PUBLIC SERVICE COMPANY OF COLORADO

March 1, 1985
Fort St. Vrain
Unit No. 1
P-85069

SUBJECT: Masonry Block Walls

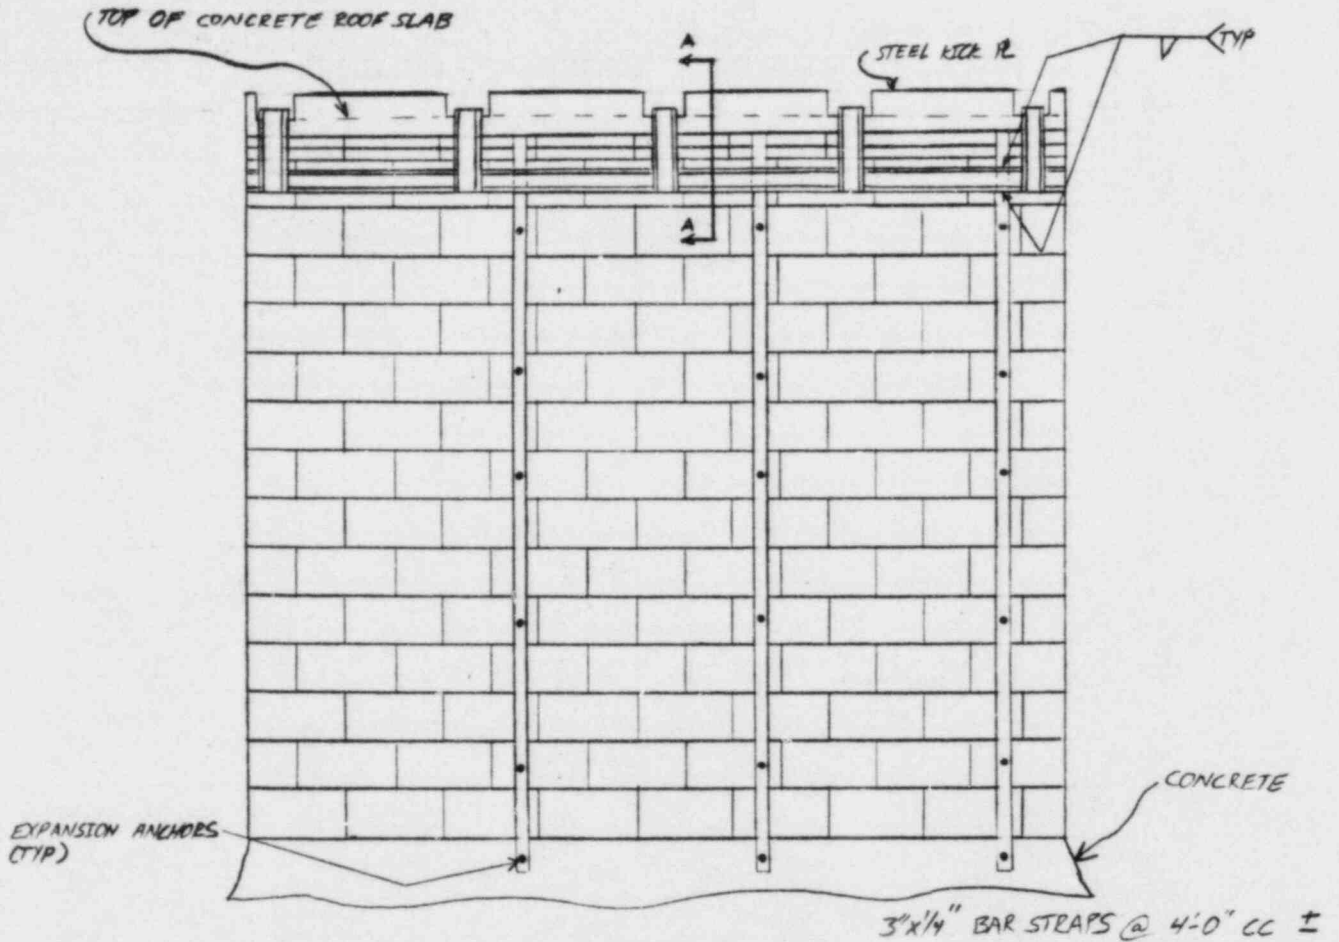
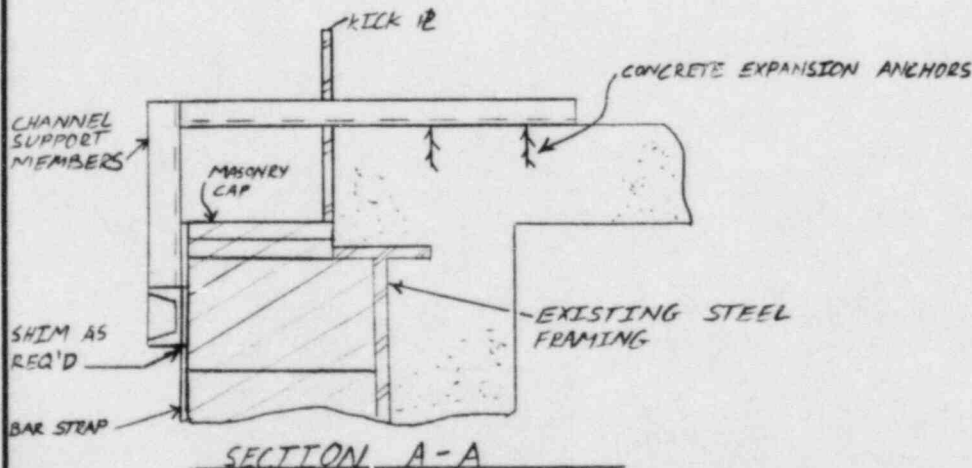
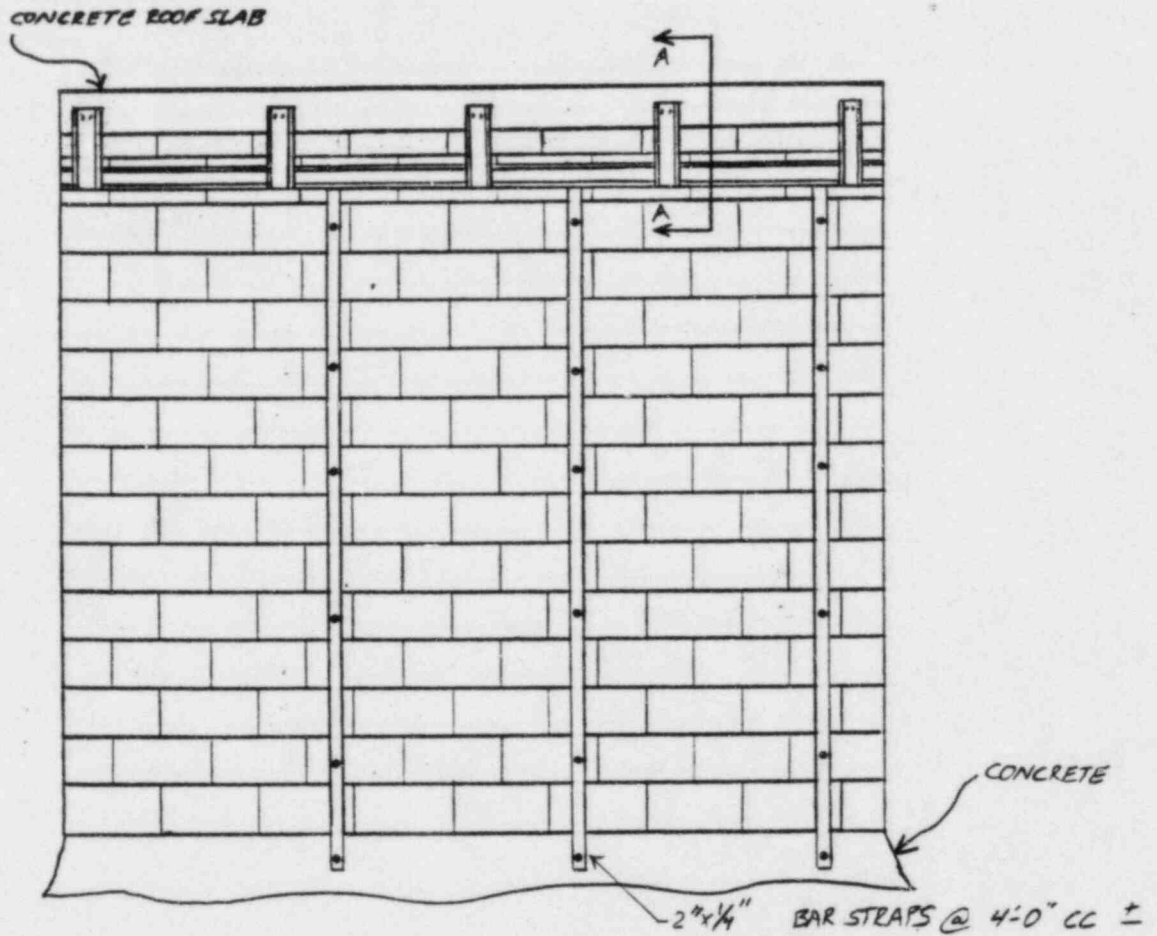
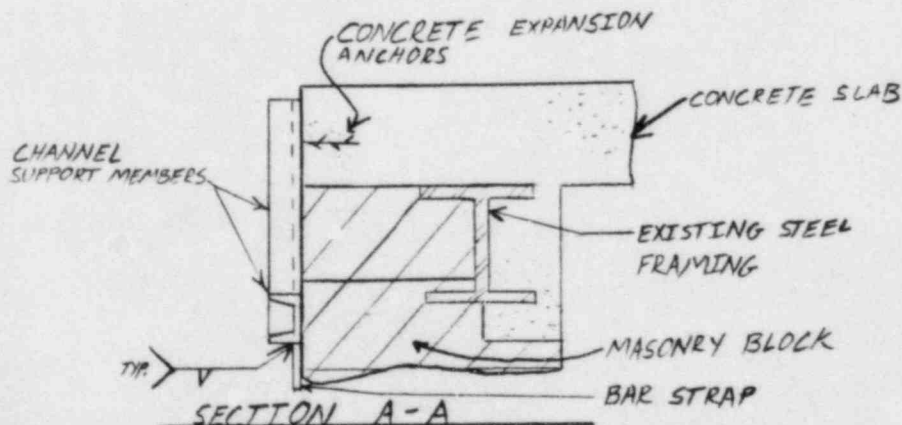
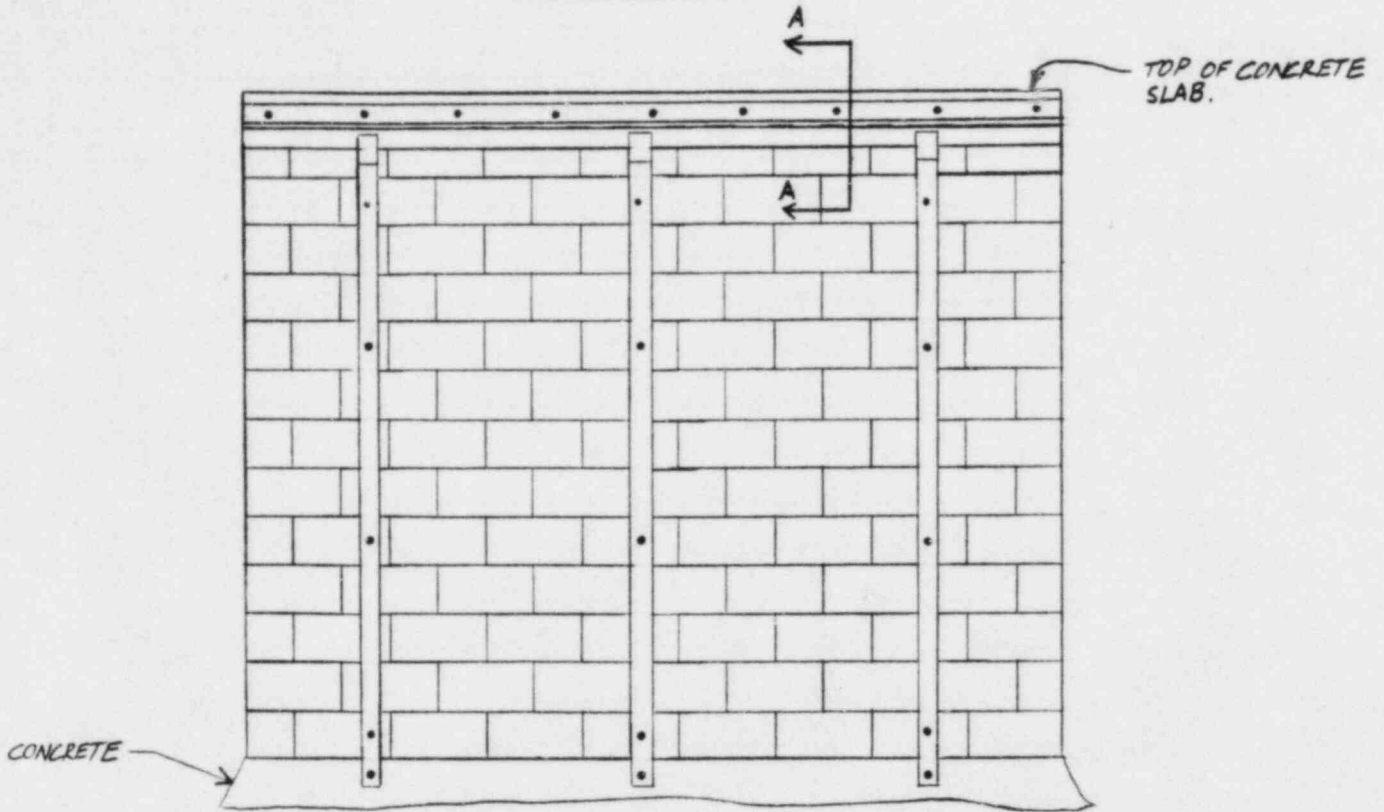
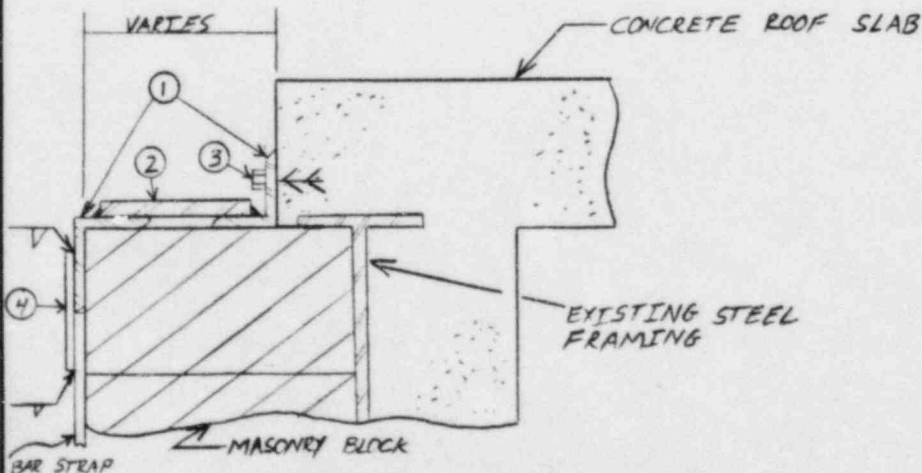
Provide details of modifications which will be made to the tops of turbine room walls #4, #6, #7, #8, and #9 in order to qualify these boundaries as pinned joints.

Lateral restraints will be added to the tops of these walls as shown in Attachment 1, Pages 14 through 16. This work will be completed by August 2, 1985.

TYPICAL REINFORCING DETAIL AROUND OPENINGS

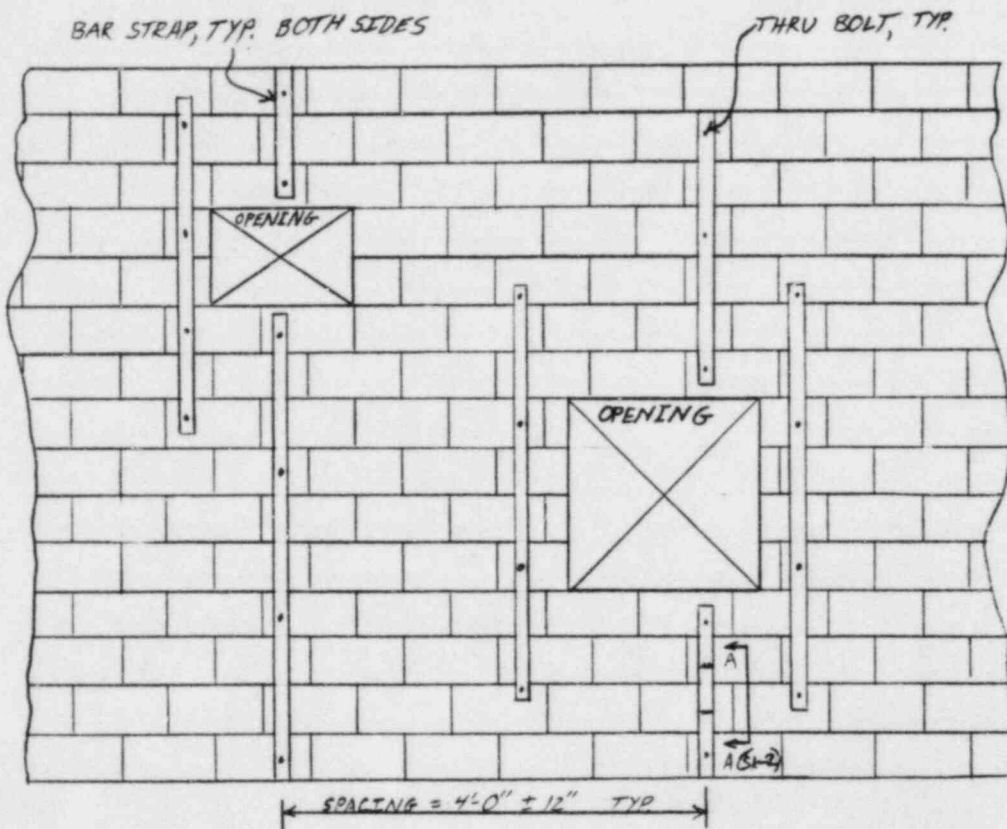
Does a change notice deviation request exist which allows the deletion of one bar strap on one side of a rectangular penetration through wall #12.

No deviation request exists which allows for the deletion of a bar strap on one side of the penetration through wall #12. A field audit was performed to examine all walls which have been reinforced to insure that all penetrations were properly framed out with bar straps. No other walls were found to have discrepancies. Therefore, PSC considers the missing strap on wall #12 to be an isolated incidence. The missing strap on the penetration in question will be installed as originally specified by August 2, 1985.
